Re: Question About ADU Construction on Neighboring Lot

3021 15TH NW, Washington, DC 20017

Re: Zoning Questions - 3021 15TH ST NE

The following pertains to a proposed accessory apartment being built at 3021 15th Street NE, Washington, D.C. 20017. For at least the reasons summarized below, the owners of 1507 Irving Street respectfully contest the placement of the permitted construction as nonconforming with the plain meaning of the Zoning Regulations of 2016.

(1) PROPOSED SITE PLAN

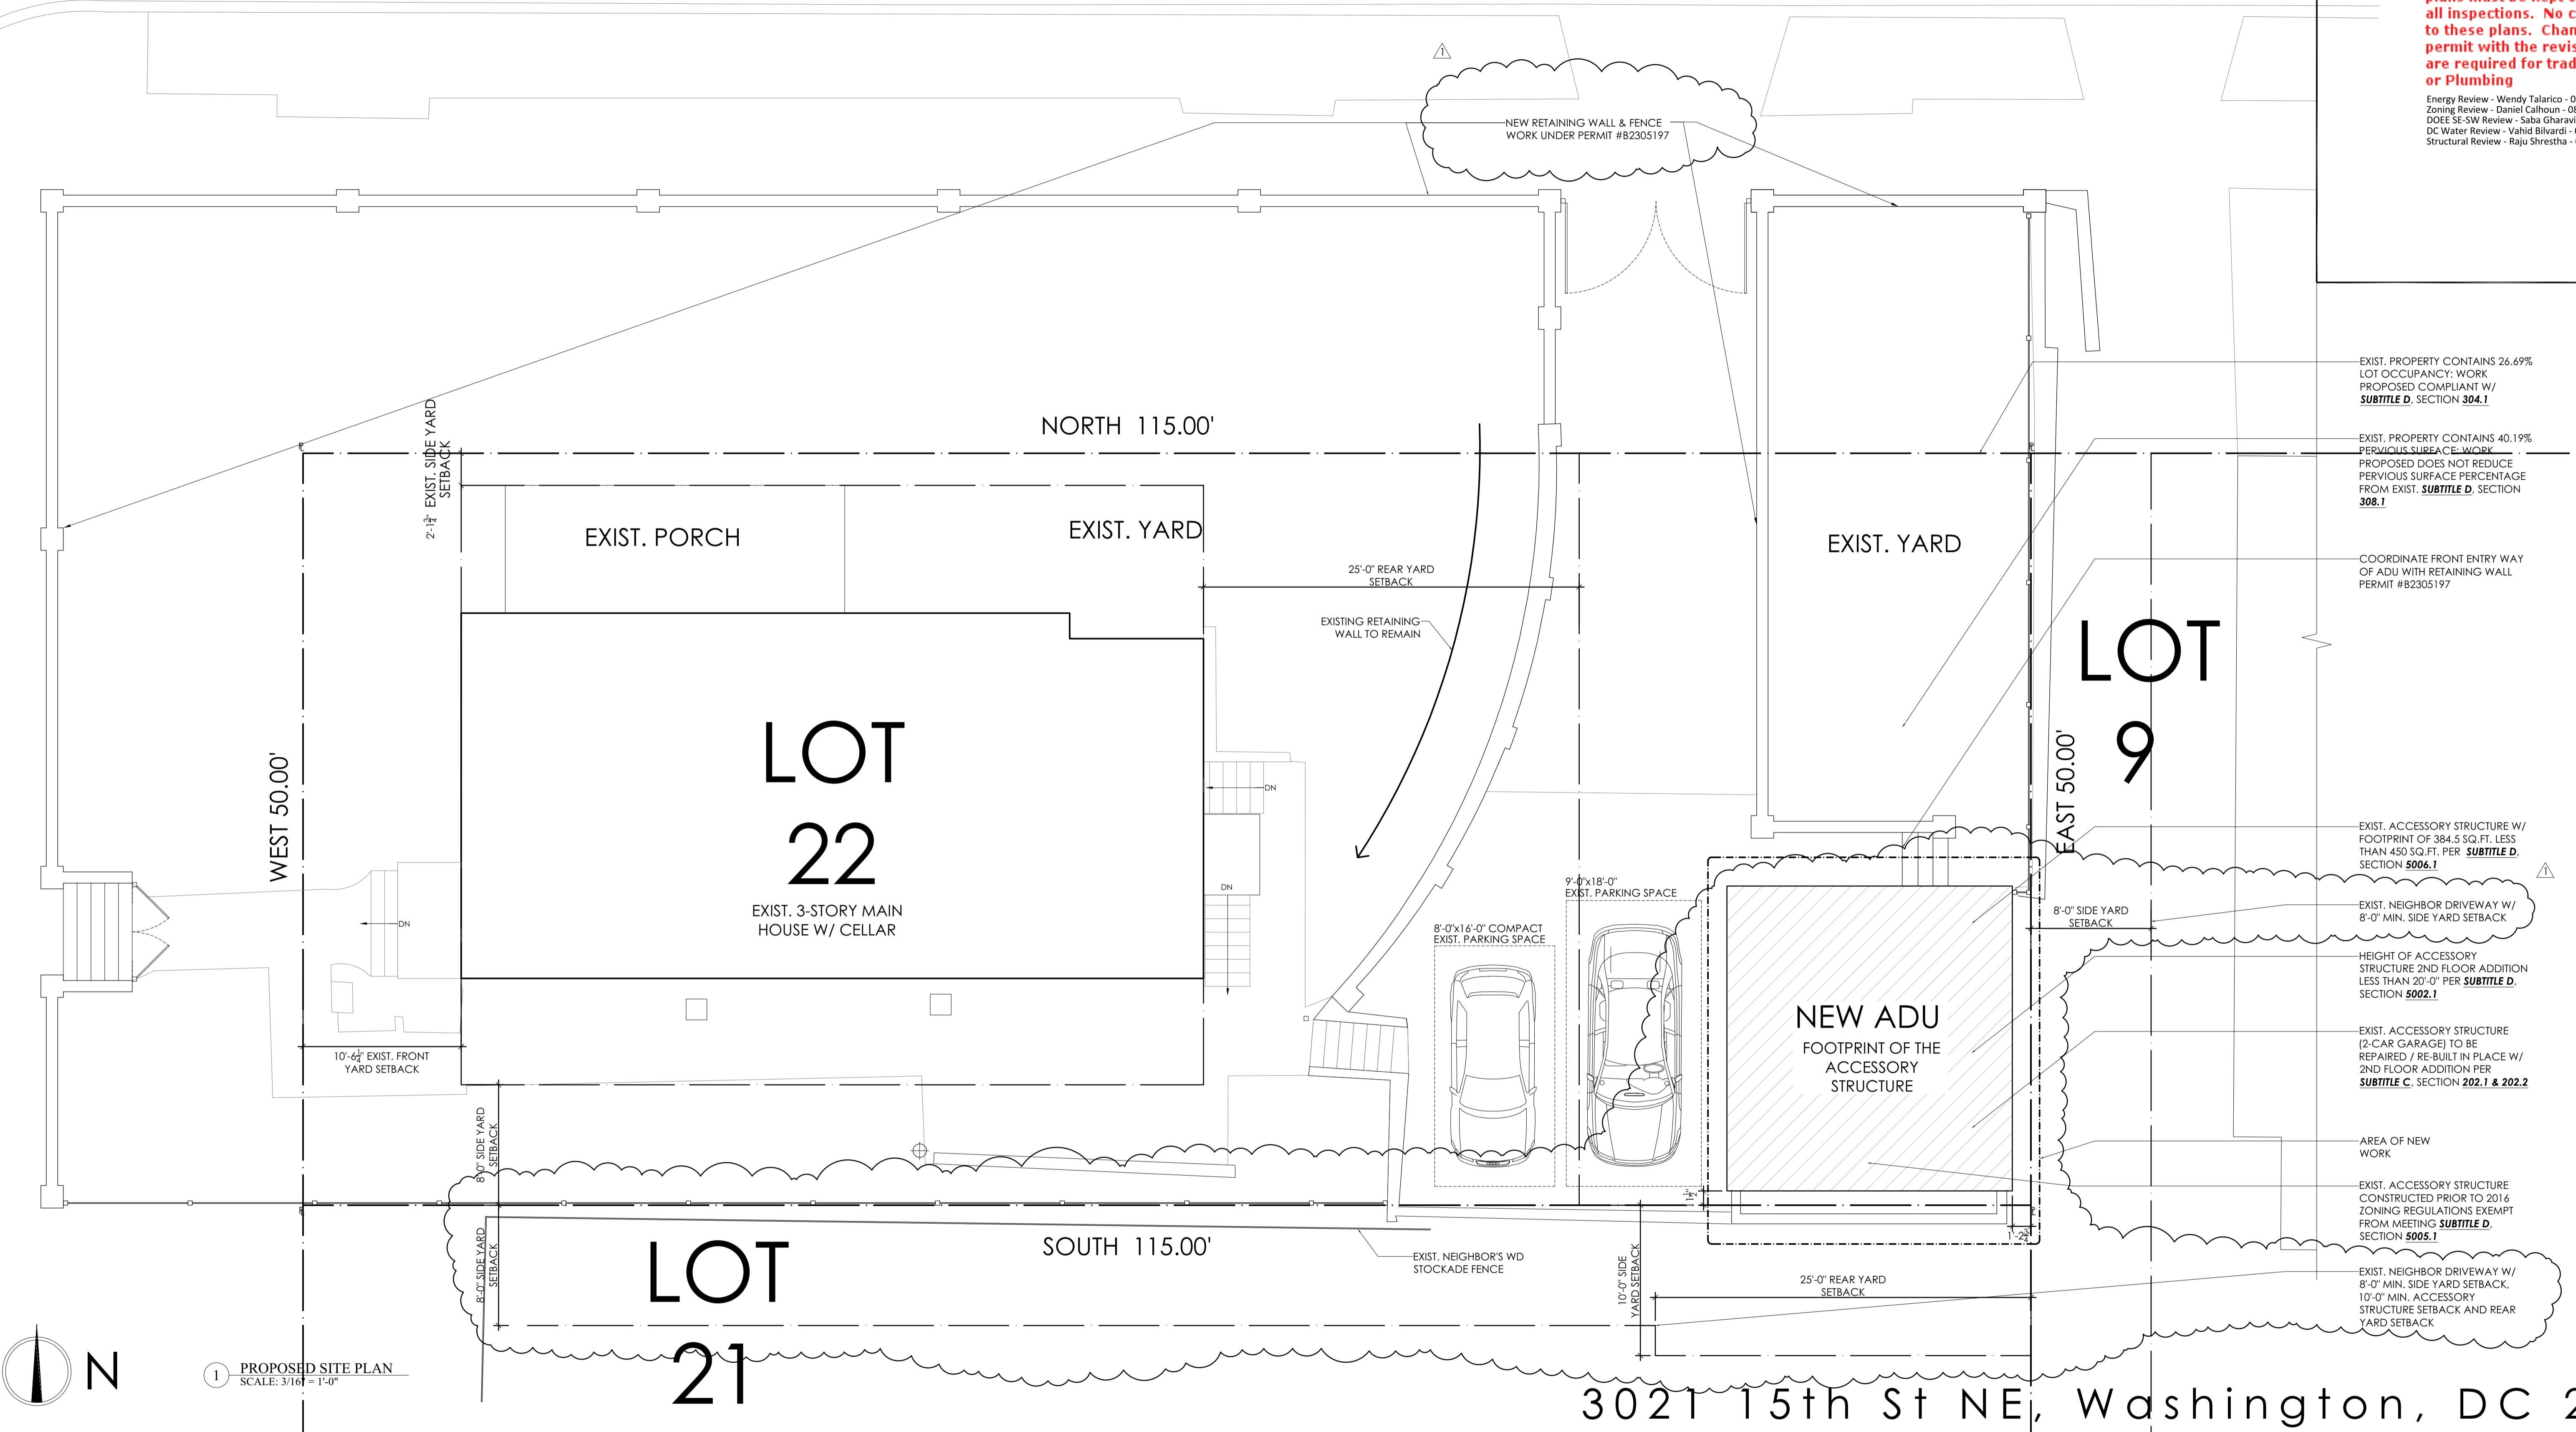
I spoke to my supervisor(cc'd), as well as the Zoning Administrator(cc'd), and the Deputy Zoning Administrator(cc'd) regarding your questions, and they agree with the determination of the original permit reviewer, Mr. Daniel Calhoun, that the approved permit set does demonstrate compliance with the Zoning Regulations for the proposed Accessory Structure.

As discussed in our phone conversation, the side yard setback development standards of Subtitle D § 208.2 do not apply to Accessory Structures because accessory structures have their own development standards found in 11-DCMR Subtitle D Chapter 50. The key points found in chapter 50 are the following:

The Accessory Structure also appears to be within the maximum building area of 450 SF, since the existing structure is approximately 385 SF in size. As we discussed over the phone, if the footprint has enlarged, then that would require a revision to the building permit. However, even if they demolished the existing structure and rebuilt it, that would not technically be exceeding the scope of the permit because it is an Accessory Structure that meets all of the development standards for the R-1B zone, and could be approved outright if a new permit application were submitted today for a new Accessory Structure. The existing structure does not contain any non-conformities, and the approval does not rely on the existing structure remaining.

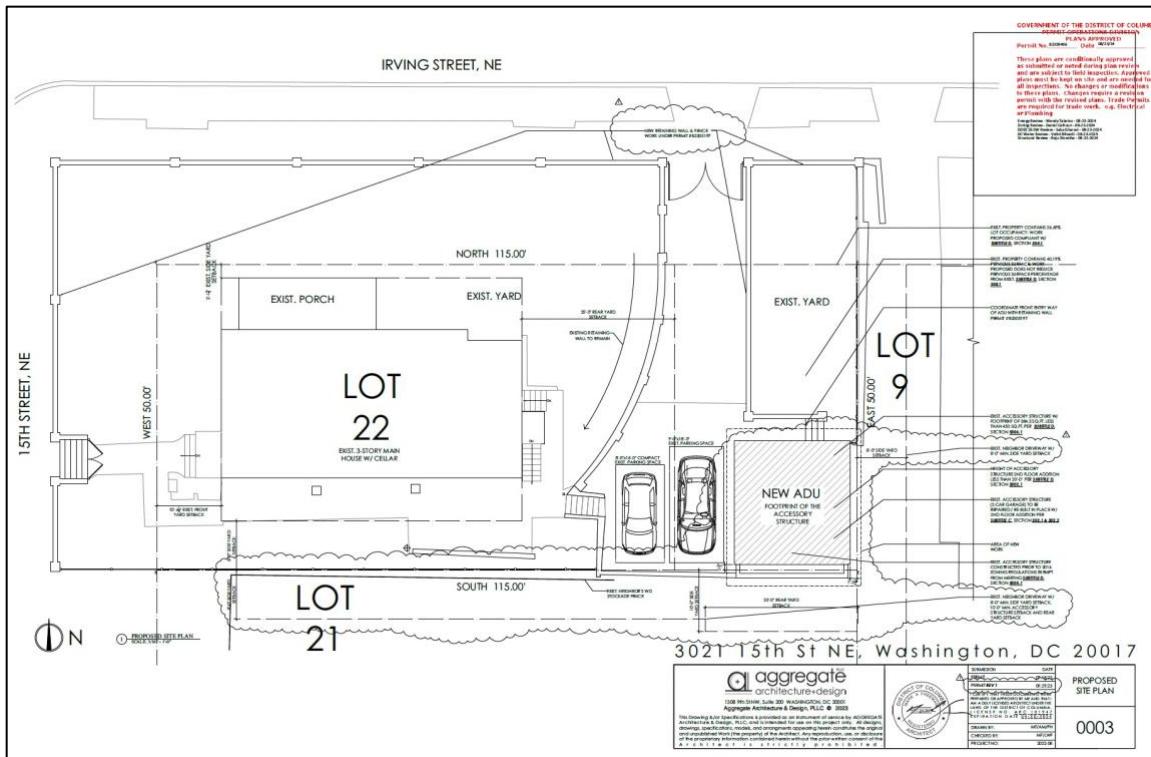
As summarized above, Subtitle D, Chapter 2 provides that, in “any of the R-1 zones” that the “principal building” on the lot “shall be a detached building.” Subtitle D, § 200.3. Subtitle D, Chapter 2 provides that R-1 lots are limited to no more than one “principal dwelling unit” and one “accessory apartment” Subtitle D, § 201.1. Accessory apartments in in the R-1 zone may be located within the principal dwelling unit or as a detached accessory building. Subtitle D, § 201.1; Subtitle U, § 253.2. The existing principal building (annotated in green) and the proposed accessory apartment (proposed as a detached building) (annotated in red) are shown below:

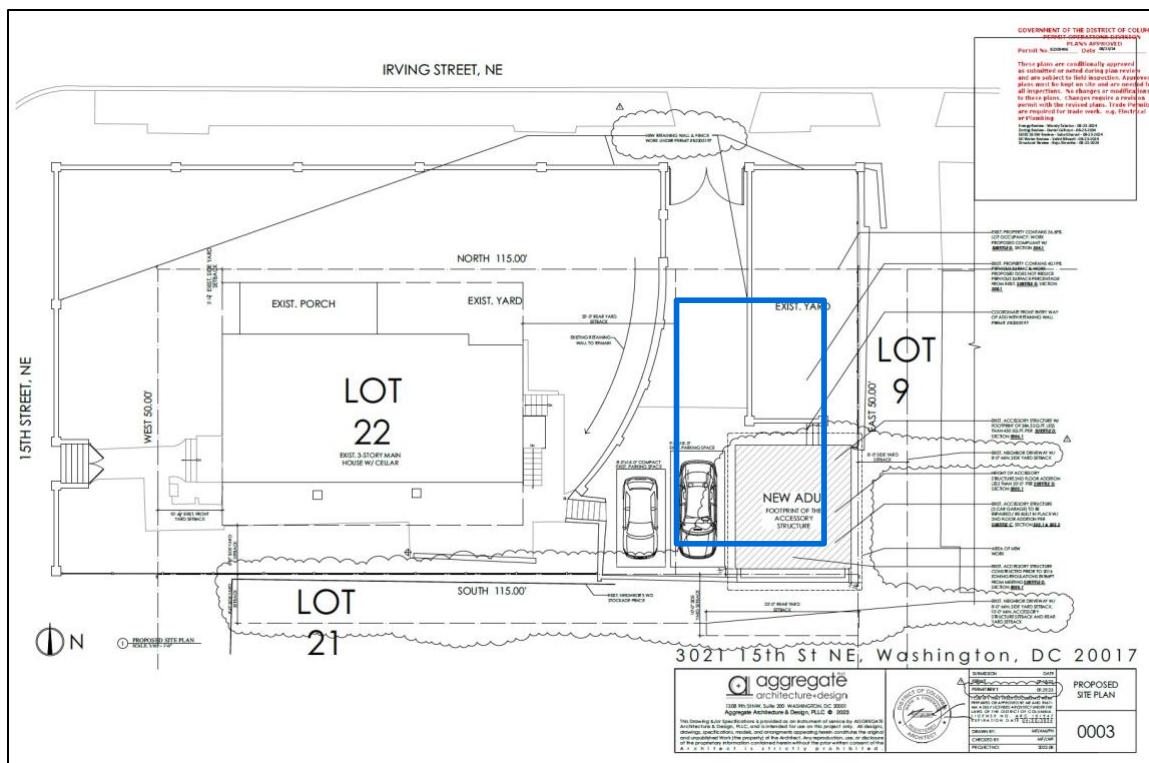
The location of the proposed accessory apartment does **not** comply with the Regulations. As required by both Subtitle D, Chapter 2, and Subtitle D, Chapter 50, the proposed construction cannot be placed in either side yard of the principal building on Lot 22 due to the placement and size of the principal building on the lot. *See* Subtitle D, § 208.2 (requiring all detached buildings have a side yard of at least eight feet in the R-1 zone) and Subtitle D, § 5005.1 (imposing an additional requirement that, in addition to leaving a minimum of eight feet of side yard between the accessory apartment and the lot line, that the accessory apartment must leave a minimum of ten feet between the principal dwelling and accessory building). Likewise, an accessory building cannot be located within the required rear yard of the principal building. Subtitle D, § 207.1 (requiring 25 foot minimum rear yard depth); Subtitle D, § 5005.1 (confirming that the required 25 foot minimum rear yard is not enlarged).

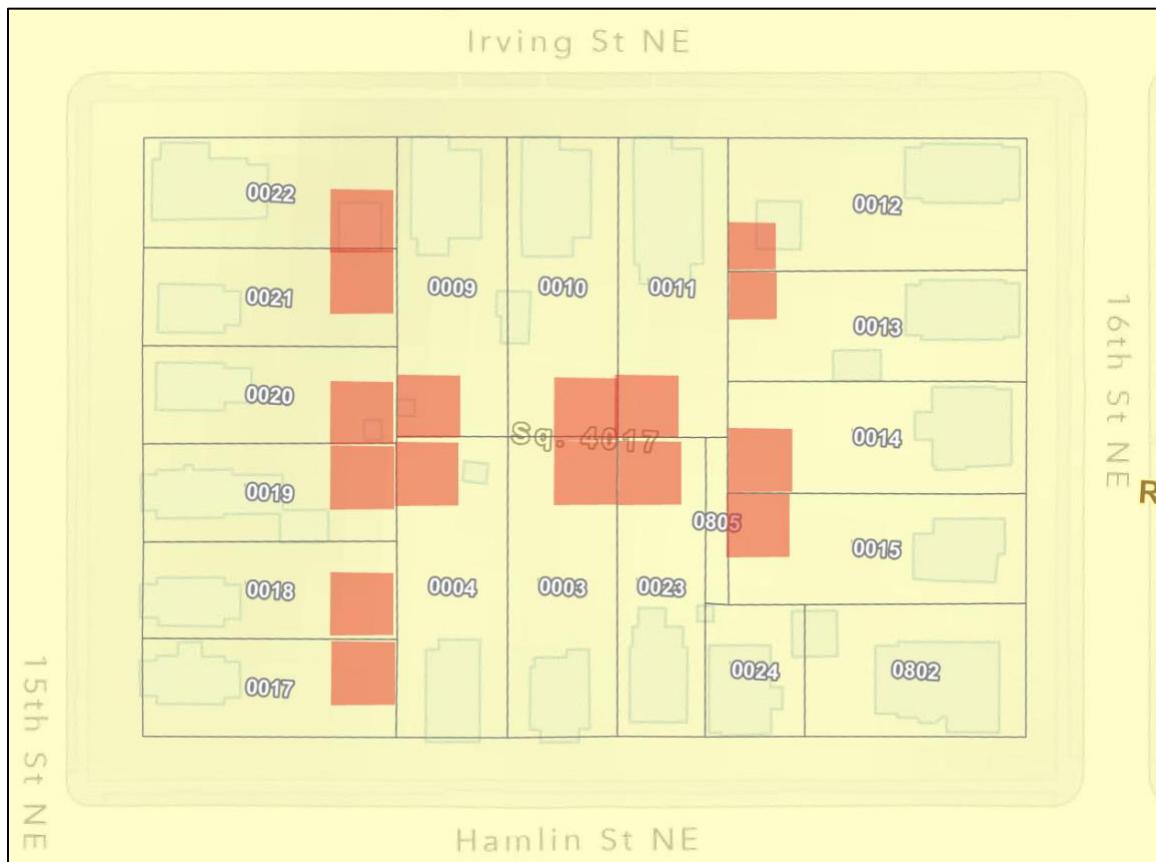
Additionally, because the proposed construction is for an detached building in the R-1 zone, an additional restriction on its location exists: “***all detached buildings . . . shall***” have “[*two* (2) side yards, each a ***minimum of eight feet*** (8 ft.) in width.” Subtitle D, § 208.2. As previously noted, the Regulations define “side yard” as a “yard between any portion of a building or other structure and the adjacent,” i.e., “having a common border,” “abutting,” or “touching”) lot line. Subtitle B, § 102; *Adjacent*, WEBSTER’S UNABRIDGED DICTIONARY, <https://unabridged.merriam-webster.com/unabridged/adjacent> (last visited Oct. 5, 2024). Thus, a detached building must be eight feet away from the lot lines that it shares a border with to comply with the detached building Regulations (annotated in blue):

For at least these reasons, the Irving Street Homeowners respectfully request that the proposed accessory apartment be set back 8 feet from their property line—as required under the plain meaning of the Regulations, as well as to preserve the safety and value of their home.
